September 10, 2004

**SUBJECT: Supplemental Responsiveness Summary for the Action Memorandum for Accelerated Retrieval of a Described Area within Pit 4 (FM DP-FFA/CO-04-011)**

## Supplemental Responsiveness Summary for the Action Memorandum for Accelerated Retrieval of a Described Area within Pit 4

Figure 1. Diagram of the general process flow and disposal logic for major waste streams resulting from the Accelerated Retrieval Project.

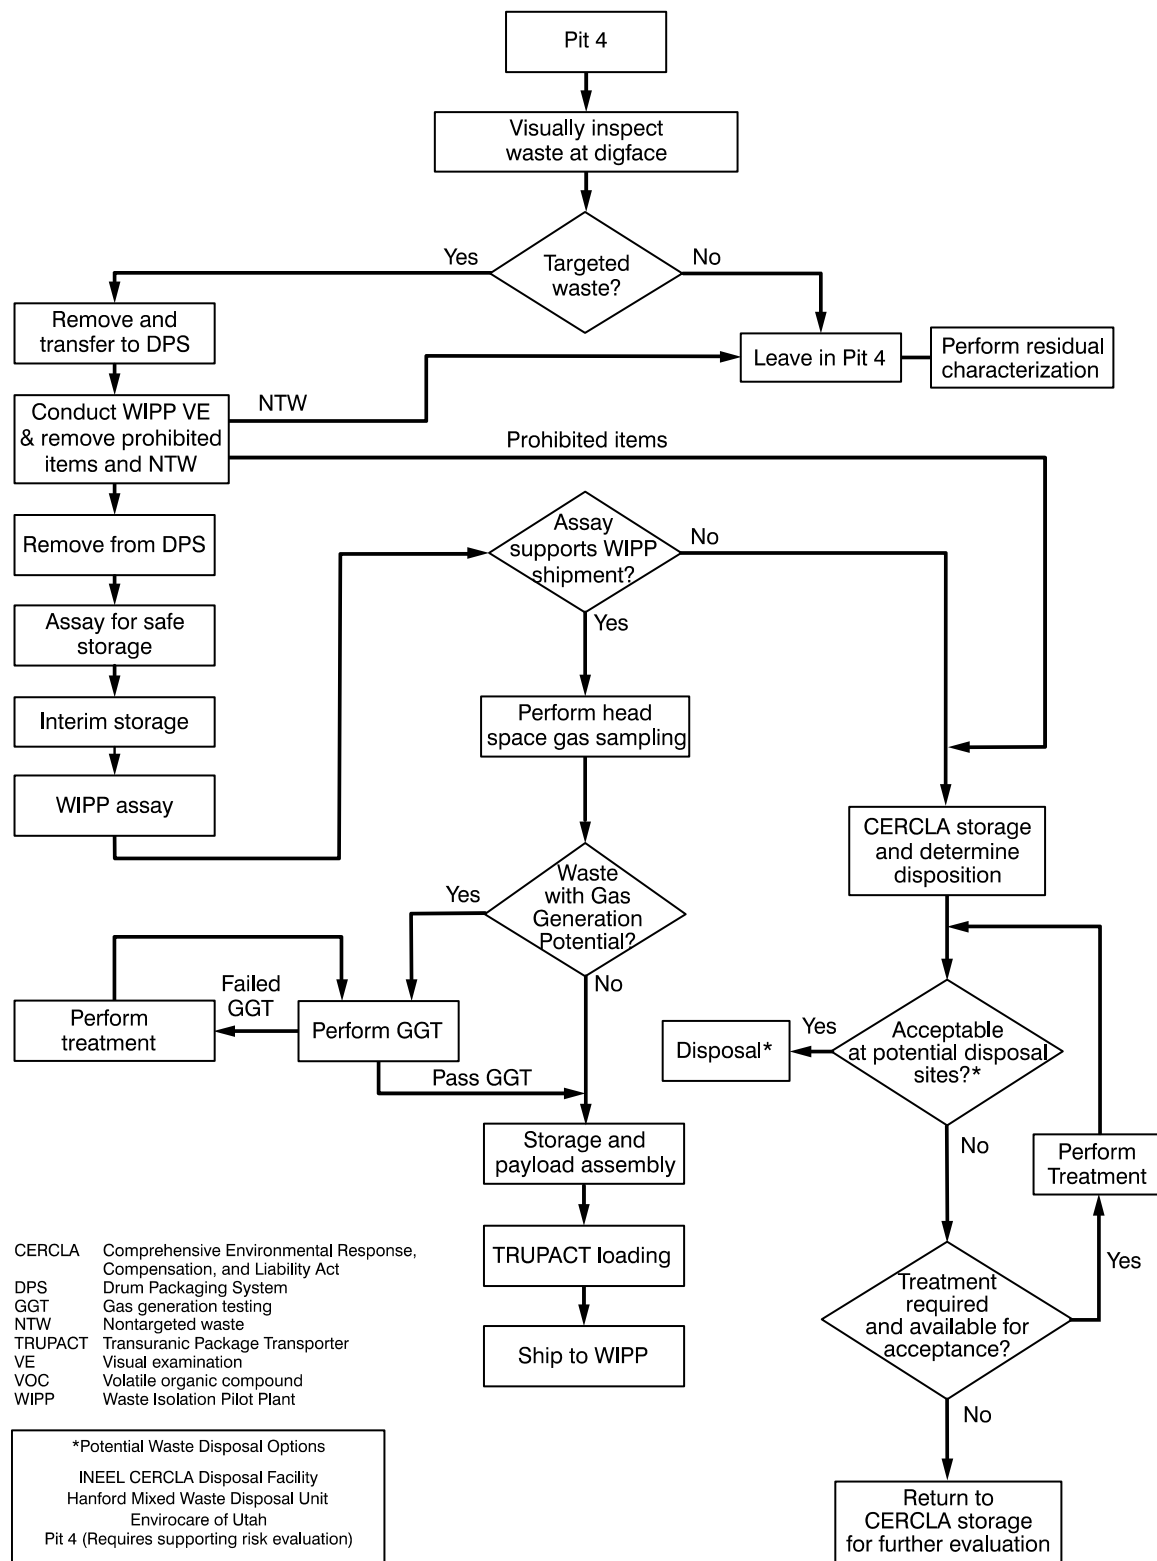
**Topic #7:** Public concern was expressed about compliance with legal requirements such as Resource Conservation and Recovery Act (RCRA) (42 USC § 6901 et seq., 1976) land disposal restrictions, the dense-pack drum storage arrangement, and Toxic Substances Control Act (TSCA) (15 USC § 2601 et seq., 1976) requirements for polychlorinated biphenyl (PCB) management.

At the suggestion of a commenter, a generalized process flow chart (see Figure 1) has been developed to illustrate the major process steps, associated decision points, and potential waste disposal options that are being evaluated as part of the proposed action.

**Response:** See the response for Topic #6 under Section 3, “General Comments by Topic.” See response to Comment #66. Figure 1 illustrates the process flow and disposal logic for the major waste streams resulting from the AR Project.
